ECE/TRANS/WP.29/GRE/2006/28
23 January 2006

PROPOSAL FOR DRAFT AMENDMENTS TO REGULATION No. 48

(Installation of lighting and light-signalling devices)

Transmitted by the experts from the Netherlands and Germany

Model A

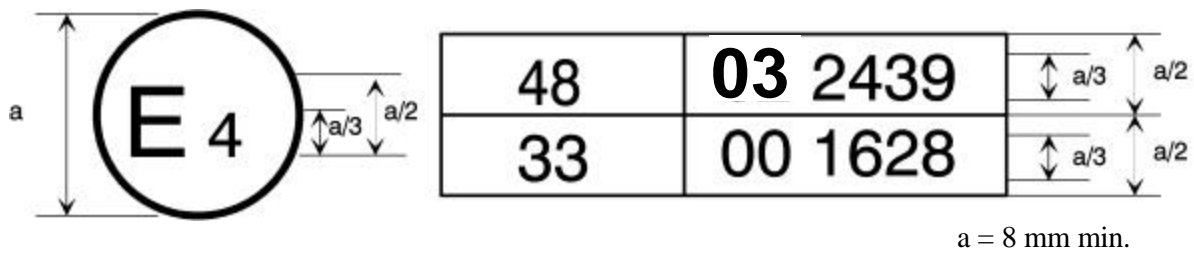
The above approval mark affixed to a vehicle shows that the vehicle type concerned has, with regard to the installation of lighting and light-signalling devices, been approved in the Netherlands (E4) pursuant to Regulation No. 48 as amended by the ~~02~~ **03** series of amendments. The approval number indicates that the approval was granted in accordance with the requirements of Regulation No. 48 as amended by the ~~02~~ **03** series of amendments.

The same justification as for paragraph 4.2.
